MEMORANDUM

SUBJECT: Modifications to the TTFSS V4

Refer to: LIGO-E1700364-v2

This document lists the modifications to the 4th generation TTFSS, based on PCB D1700346-v1 and on schematics <u>D1700077</u>, <u>D1700076</u> and <u>D1700078</u>.

Change 1:

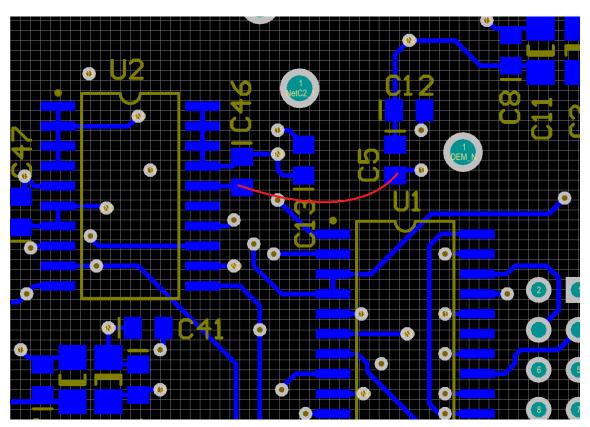
U2 is missing the +15V rail. Add a jumper wire between the C5 pad towards U1 and the C46 pad towards U1 (Servo board, D1700077, bottom).

Change 2:

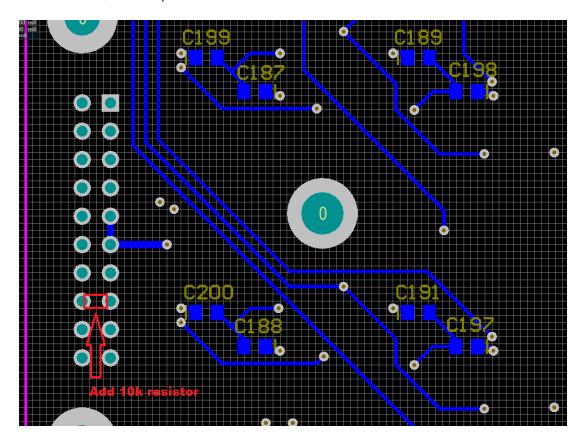
Input to U26 is floating when OPT4 is selected without an option board. Add a 10 k Ω resistor (R174) between pins 8 and 18 of header JP1 (Servo board, D1700077, bottom).
